Appl. No. 10/013,097
Reply Filed: November 17, 2004
Reply to Office Action of May 17, 2004

AMENDMENTS TO THE DRAWINGS

Fig. 2

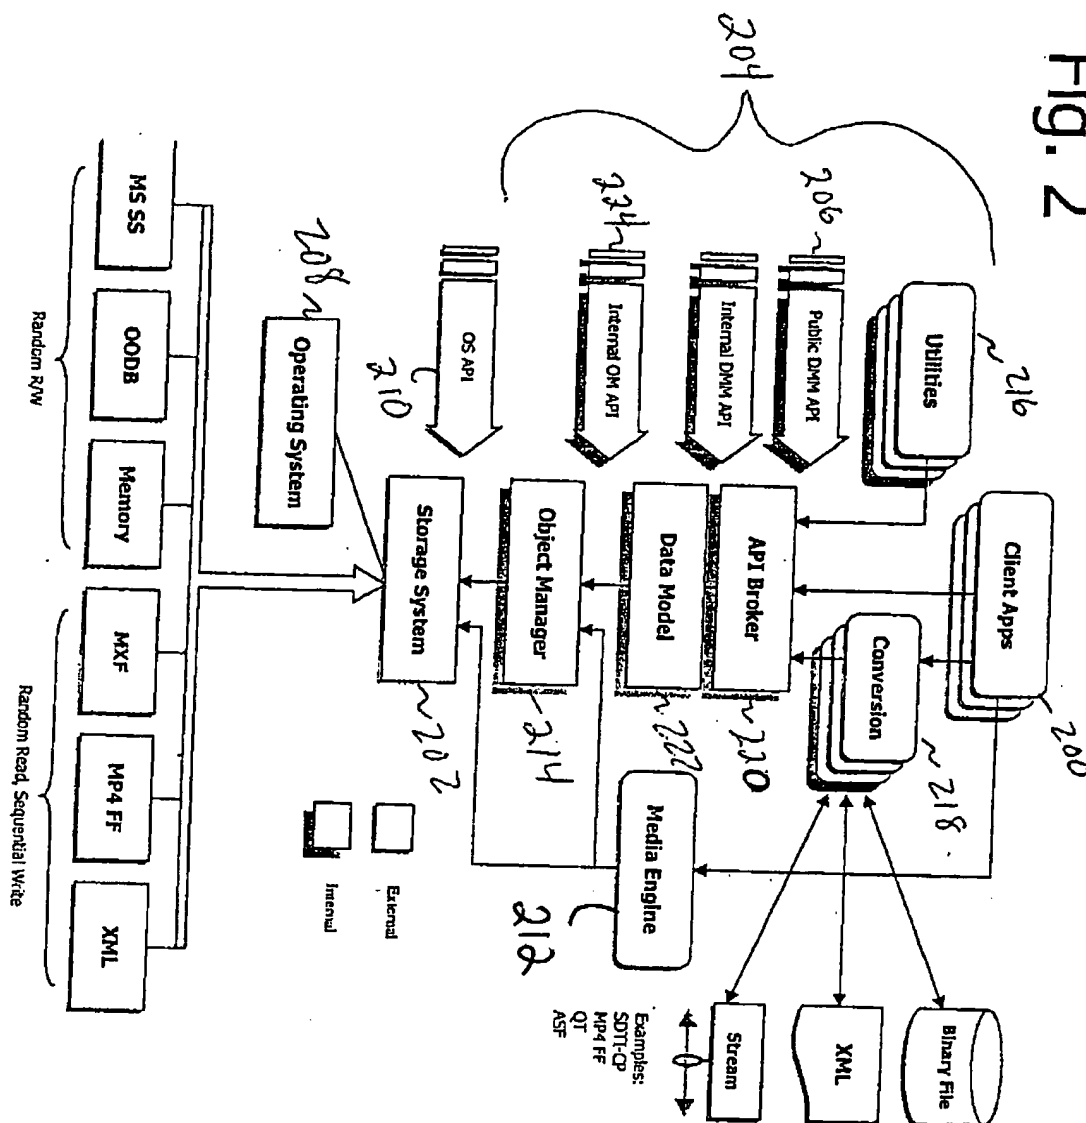
One sheet, which includes Fig. 2, replaces the original sheet including Fig. 2. In Figure 2, previously omitted element 13 has been added.
